Access Compliance Report

Public Rights-of-Way

(Curb Ramps)

Intersection ID: N/A	Main Street: MICROSOFT_WY	Cross Street: HANSON_RD	Location: NW
ADA ID: AD6C1842A35A	Ramp Type: Directional1	Initial Pass/Fail: Fail	Overall Compliance: No
Codes/Mitigation Info/Possible Solution		Field Measurements/Component Compliance

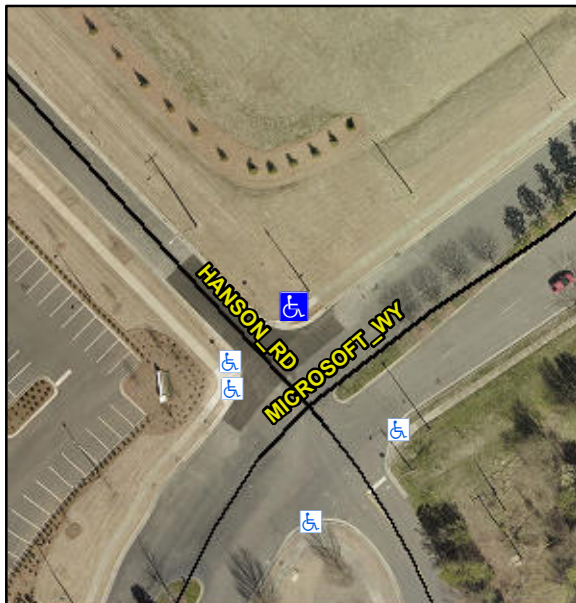
DWS LCOATED ON LNDG

PROW/ADA:

R304.5.1, R304.5.3

Remove & Replace Entire Ramp.
